Access Compliance Report

Public Rights-of-Way

(Curb Ramps)

Intersection ID: 14455	Main Street: EAST_BV	Cross Street: WINTHROP_AV	Location: NE
ADA ID: FCA83A92E34C	Ramp Type: BlendTrans1	Initial Pass/Fail: Fail	Overall Compliance: No
Codes/Mitigation Info/Possible Solution		Field Measurements/Component Compliance	
Severity Score: 1.25

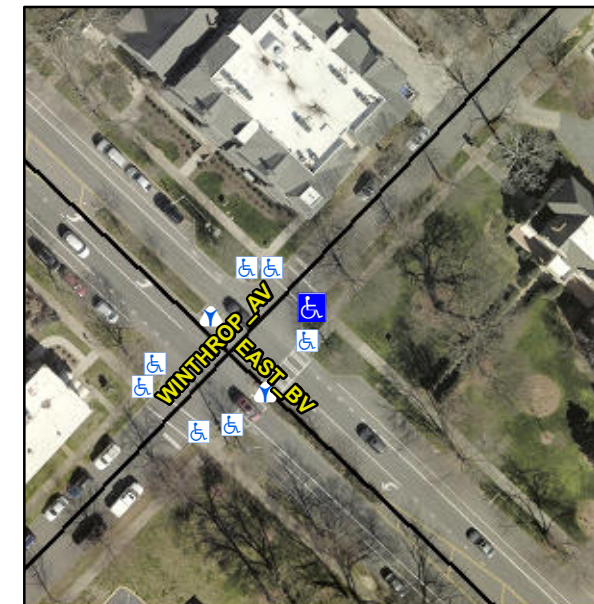
Remove & Replace Curb Ramp With Two New Directional Ramps or Equivalent.

Not Found, R304.5.3
